RECALL 24V489 / 2024-373 REMEDY INSTRUCTIONS

Make(s): MANY, SEE BELOW
Model(s): MANY, SEE BELOW
Model Year(s): 2024 - 2025

The Lippert Ladder Receiver mounted to the rear wall may have been inconsistently installed, missing the intended backer.

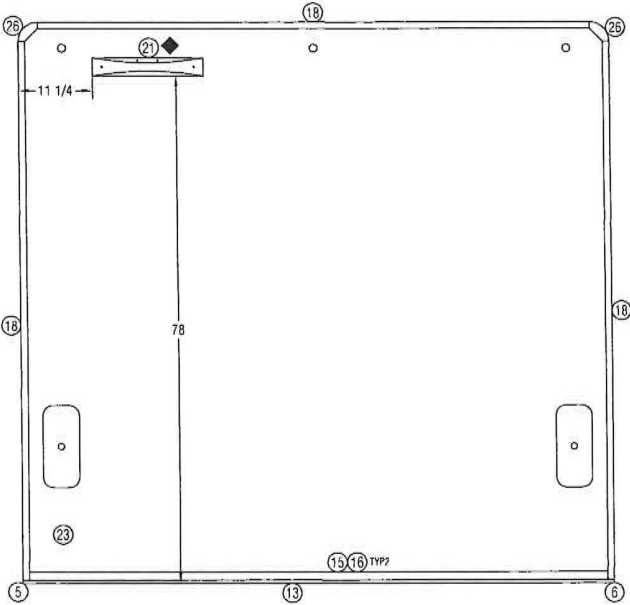
THIS DRAWING AND THE INFORMATION CONTAINED THEREON ARE THE EXCLUSIVE PROPERTIES OF COACHMEN RV. IT SHALL NOT BE COPIED OR DUPLICATED IN ANY MANNER WITHOUT OUR WRITTEN CONSENT.		REV	CHANGE DESCRIPTION	BY	DATE	PCR
		-	MODEL CHANGE WAS F100364976	-	-	MC2025
		A	ADD BRACKET AND DIM. FOR LUPPERT LADDER PCM	-	7/1/24	PCR 3803

QUANTITY	REF. NO.	PART NO.	MATERIAL OR PART DESCRIPTION
WOOD	OTHER	REM 04/17/2024	COACHMEN R.V. A DIVISION OF FOREST RIVER, INC.
CT 20XG / MM	USED ON	DO NOT SCALE	EXTERIOR PARTS, CROSS TREK
± 1/8"	± 1/16"	SCALE	DRAWING # F100546855
± .125"	± .063"	DO NOT SCALE	REV A
± 1°	± .5°		SHEET 2 OF 3

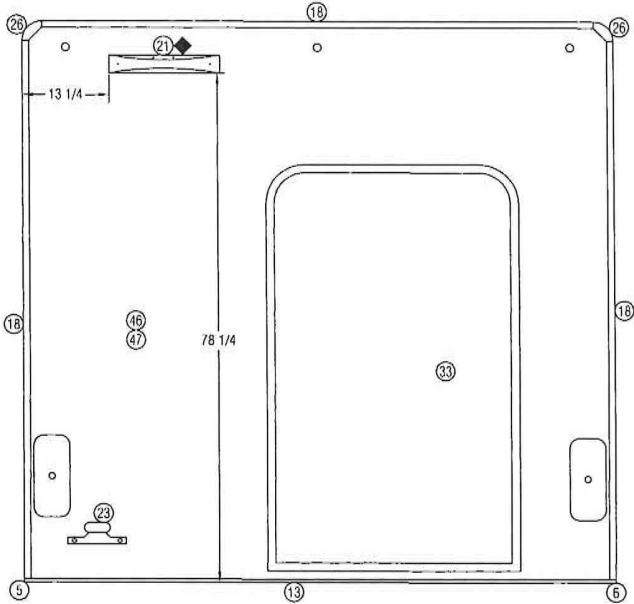
REV	CHANGE DESCRIPTION	BY	DATE	PCR
1	MODEL CHANGE WAS F10020285R	-	-	MC2025
A	ADD BRACKET AND DIM. FOR UPPER LADDER REM	7/7/24	PCR 3803

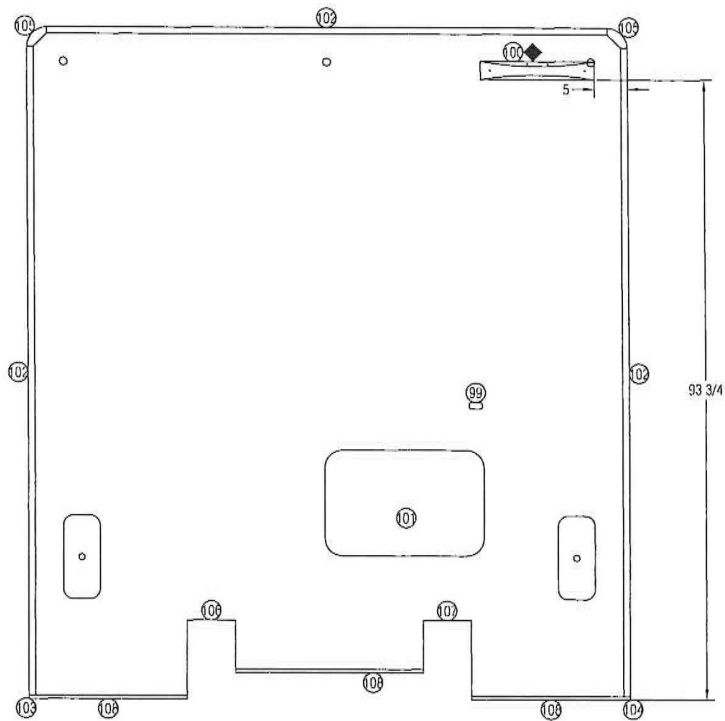
THIS DRAWING AND THE INFORMATION CONTAINED THEREON ARE THE EXCLUSIVE PROPERTIES OF COACHMEN RV. IT SHALL NOT BE COPIED OR DUPLICATED IN ANY MANNER WITHOUT OUR WRITTEN CONSENT.		REV	CHANGE DESCRIPTION	BY	DATE	PCR
		1	MODEL CHANGE WAS F100404104	-	-	MC2025
		A	ADD BRACKET AND DIM. FOR LIPPERT LADDER	REM	7/1/24	PCR 38013

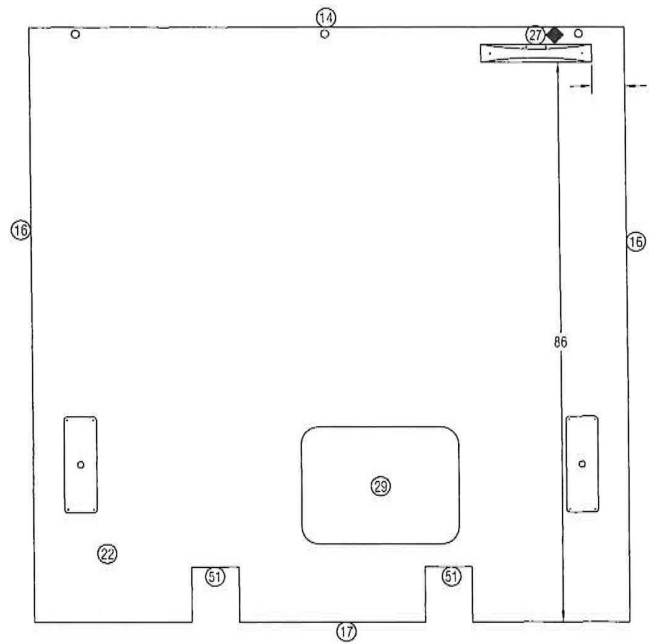
THIS DRAWING AND THE INFORMATION CONTAINED THEREON ARE THE EXCLUSIVE PROPERTIES OF COACHMEN RV. IT SHALL NOT BE COPIED OR DUPLICATED IN ANY MANNER WITHOUT OUR WRITTEN CONSENT.		REV	CHANGE DESCRIPTION	BY	DATE	PCR
		1	REPLACES F100412882	-	-	MC2025
		A	ADD BRACKET AND DIM. FOR LIPPERT LADDER REM	7/1/24	PCR 3803

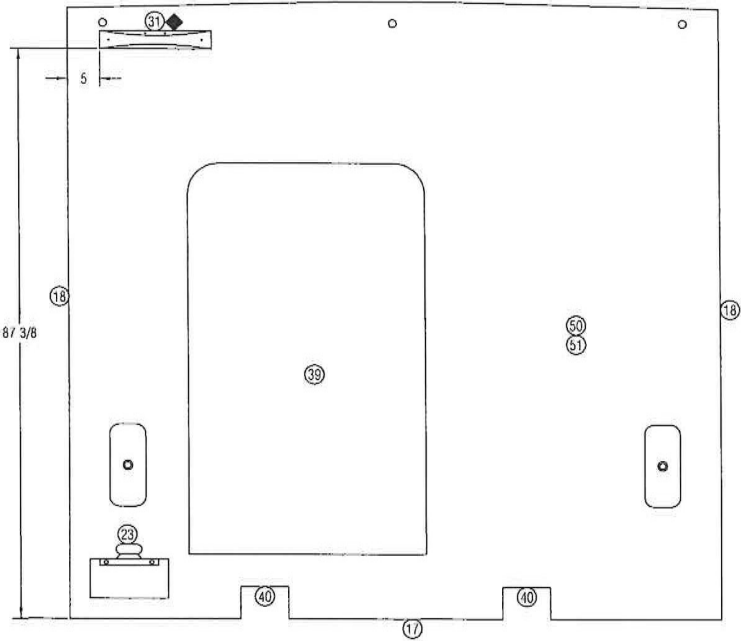
THIS DRAWING AND THE INFORMATION CONTAINED THEREON ARE THE EXCLUSIVE PROPERTIES OF COACHMEN RV. IT SHALL NOT BE COPIED OR DUPLICATED IN ANY MANNER WITHOUT OUR WRITTEN CONSENT.		REV	CHANGE DESCRIPTION	BY	DATE	PCR
-	MODEL CHANGE REPLACES F100338142	-	-	-	-	MC2025
A	ADD BRACKET AND DIM. FOR UPPER LADDER	REM	7/1/24	PCR	3903

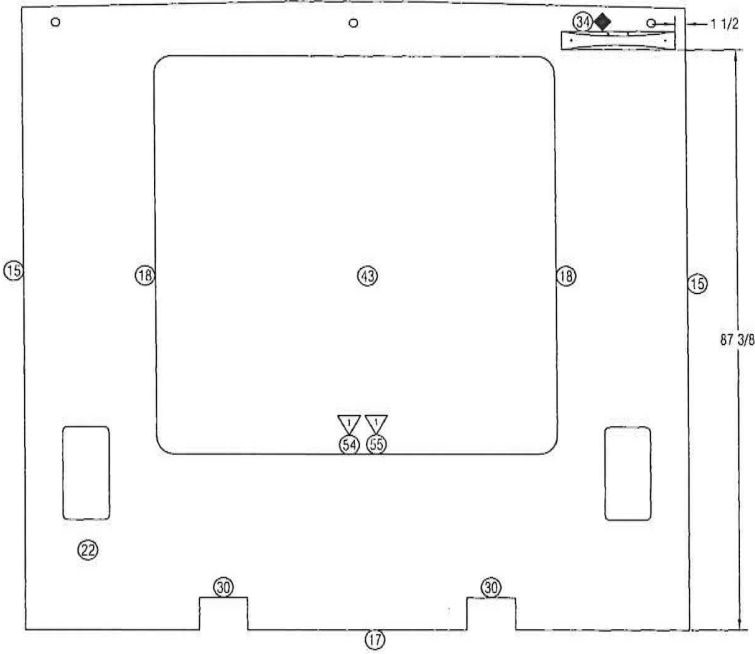
THIS DRAWING AND THE INFORMATION CONTAINED THEREON ARE THE EXCLUSIVE PROPERTIES OF COACHMEN RV. IT SHALL NOT BE COPIED OR DUPLICATED IN ANY MANNER WITHOUT OUR WRITTEN CONSENT.	REV	CHANGE DESCRIPTION	BY	DATE	PCR
	LVL	WAS F100328612			MC2024
	A	ADD BRACKET AND DIM. FOR LIPPERT LADDER	REM	7/7/24	PCR 3803

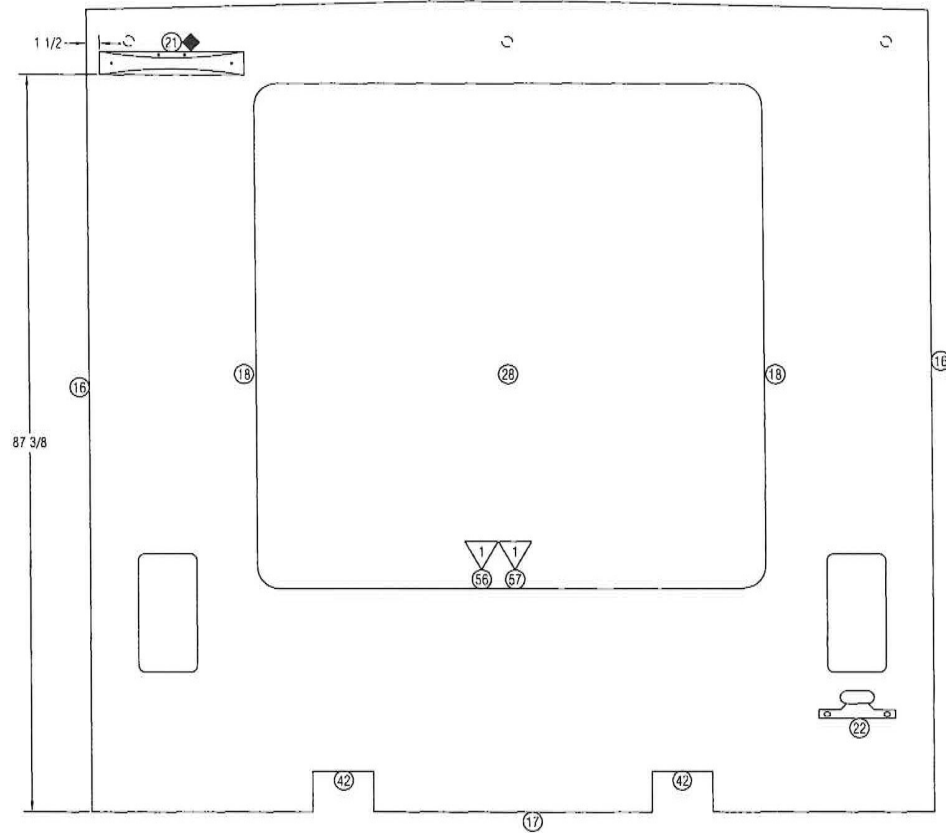
THIS DRAWING AND THE INFORMATION CONTAINED THEREON ARE THE EXCLUSIVE PROPERTIES OF COACHMEN RV. IT SHALL NOT BE COPIED OR DUPLICATED IN ANY MANNER WITHOUT OUR WRITTEN CONSENT*	REV	CHANGE DESCRIPTION	BY	DATE	PCR
	-	WAS F100328614	-	-	MC2025
	A	ADD BRACKET AND DIM. FOR LIPPERT LADDER	REM	7/1/24	PCR 380
